Subject: HIGH-FREQUENCY NOISE FROM FUEL PUMP	Bulletin No.: 01-012/23
	Last Issued : 12/19/2023

2024 CX-90 PHEV (SKYACTIV-G 2.5) with VINS lower than JM3KK*****147259 (produced before November 1, 2023)

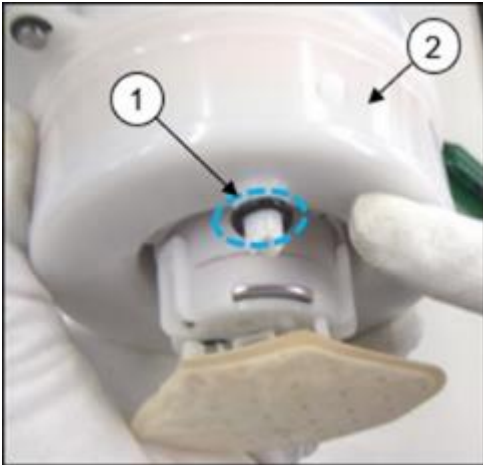
Some vehicles may exhibit a high-frequency noise from the fuel pump. When the fuel temperature is high, vaporization may occur in the return fuel from the pressure regulator valve assembled on the fuel pump unit. In that situation, the spring in the pressure regulator causes self-excited vibration, resulting in the high-frequency noise. To eliminate this concern, the shape of the pressure regulator valve in the fuel pump has been modified to control self-excited vibration by reducing pressure differences in the valve path.

1. Verify the customer concern.
2. Replace the pressure regulator in the fuel pump with a modified one according to the following procedures.
 - a. Remove the fuel pump unit according to the instructions on MGSS (FUEL PUMP UNIT REMOVAL/INSTALLATION).
 - b. Unhook (A) the tabs (1) on the fuel pump unit body (2) by using a flathead screwdriver (3), push down (B) the tabs, and remove the pressure regulator (4).

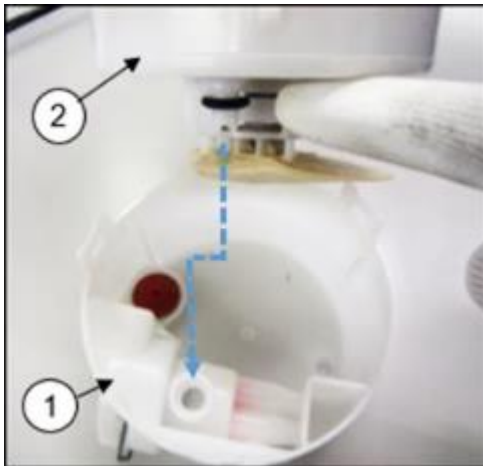
c. Replace the O-ring (1) on the fuel pump unit body (2) with a new one.

d. Install the new pressure regulator (1) to the fuel pump body (2).

NOTE: Be careful with the direction of the fuel pump body when putting together.

Push the fuel pump unit straight.

e. Check that the three tabs are properly fitted.
